Amendments to the Drawings:

REMARKS/ARGUMENTS

Fig 1

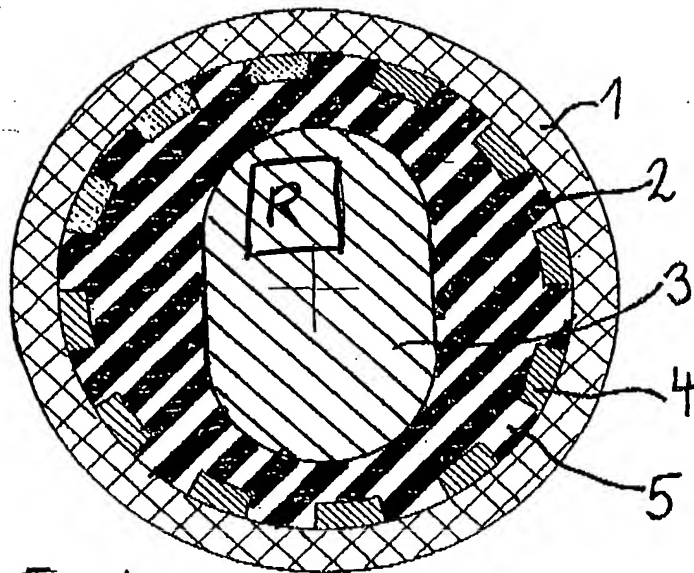
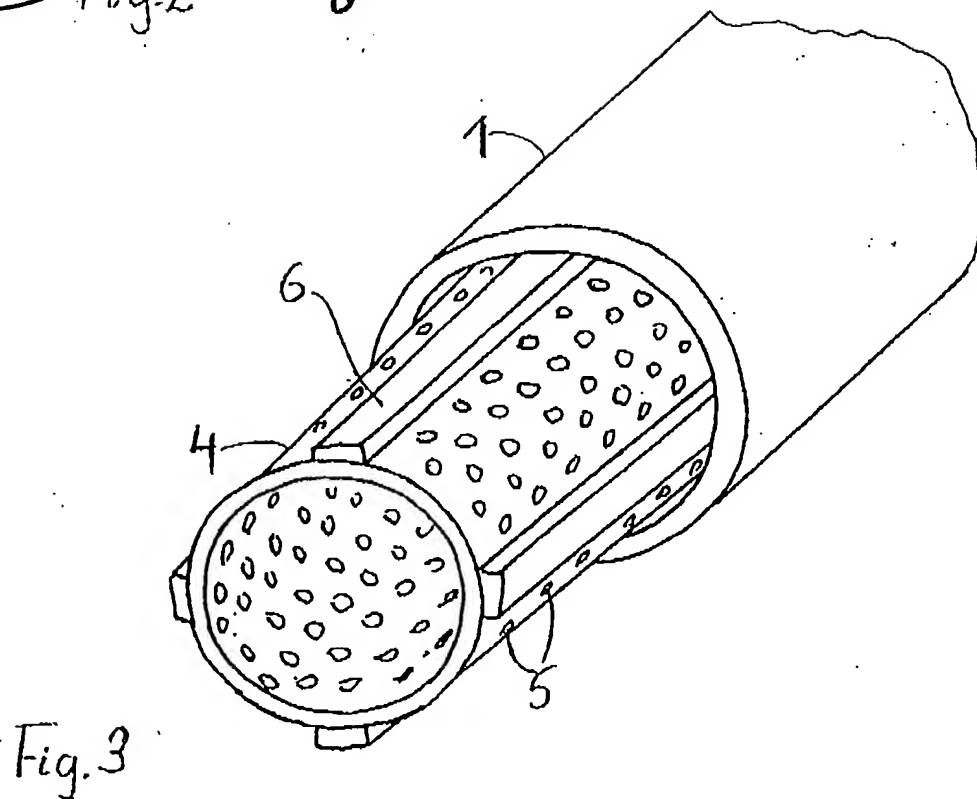
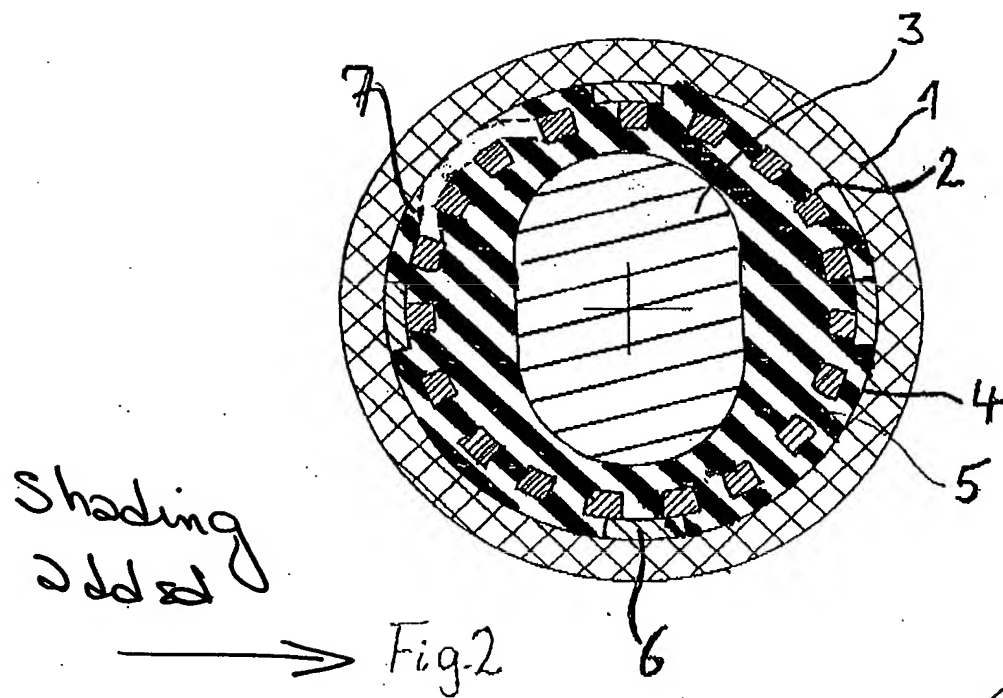
Furthermore, the rotor recited in claim 12, and discussed, for example, on page 6 of the specification, has now been indicated by the letter R in Fig. 1. In addition, the further apertures 10 in the outer tube 1 (of claim 21) have been illustrated in Figs. 8 and 9.

R added
shading added

Fig. 6

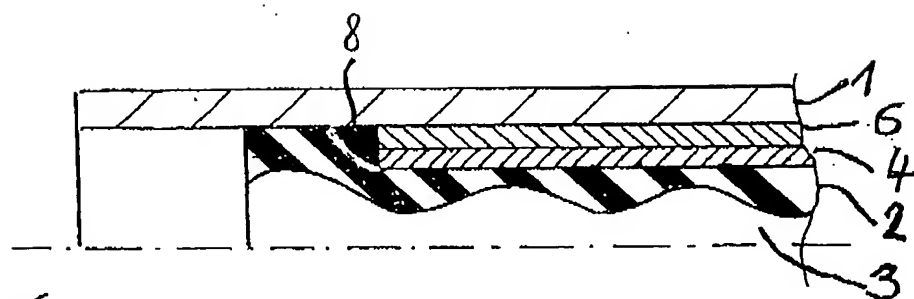
Shading
added

Fig. 7

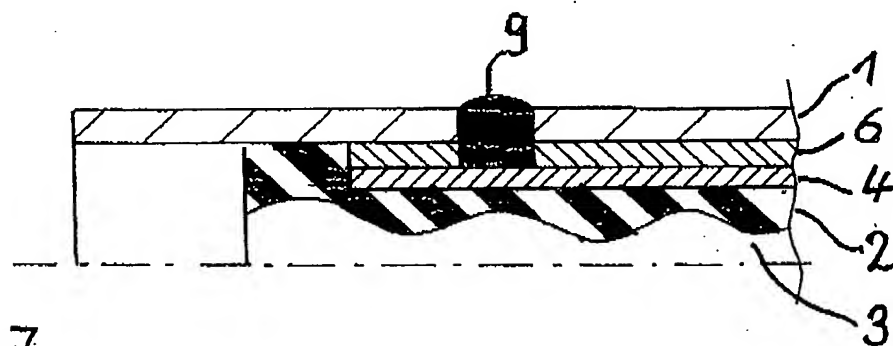
The attached sheets of drawings include changes to Figs. 1, 2, 6, 7, 8 and 9. These sheets replace the original sheets for these figures. Shading was added as required by the Examiner, the reference numeral 10 was added to Figs. 8 and 9, and the reference R was added to Fig. 1.

Fig. 8

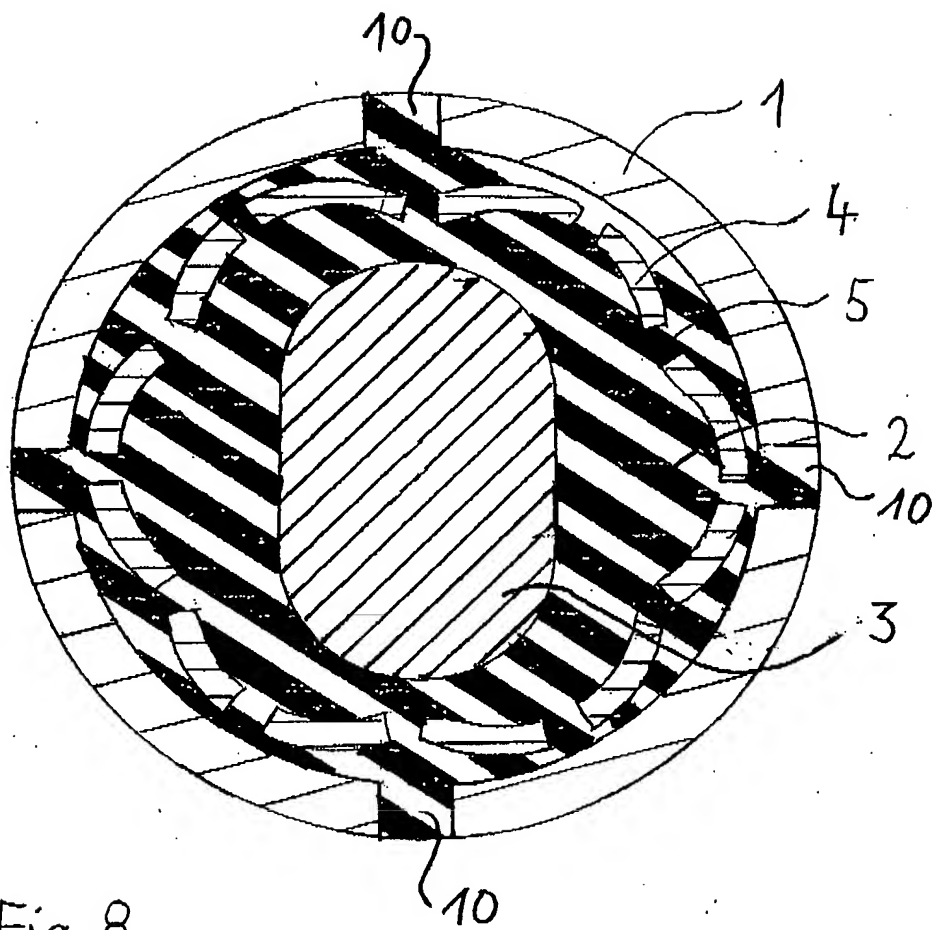
10 added
shading added

Fig. 9

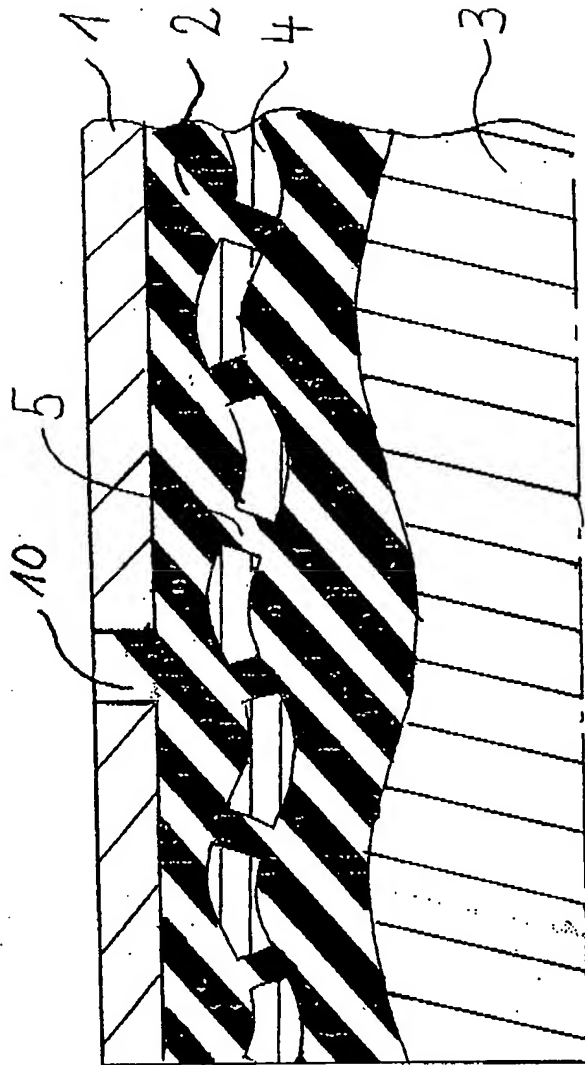
10 added

Shading added
